The Sizewell C Project, Ref. EN010012

Comments on any additional information/submissions received at D7

Suffolk County Council Registration ID Number: 20026012

Deadline 8

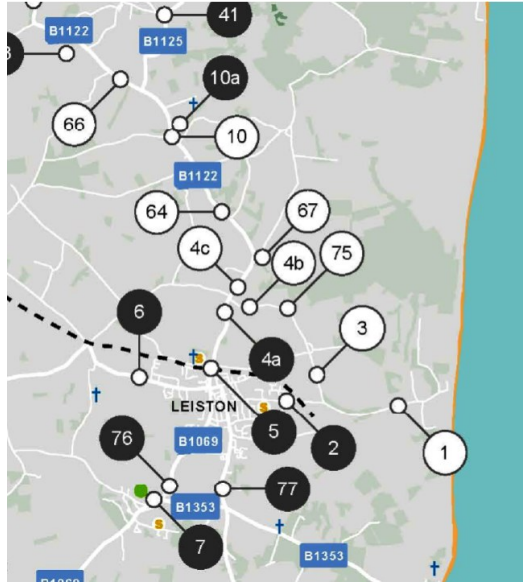
If SCC has understood SZC Co response (underlined) correctly, the number of HDVs using the B1122 between Theberton and the 'Main Site' will exceed the agreed cap of 600 HDV movements. This would not be acceptable to SCC.

Further clarification would be required on

- Where the temporary haul road would join the B1122 and what junction layout is proposed?
- Will HGVs be accessing the Main Site at the main site access, the secondary access or via SZCB site access?
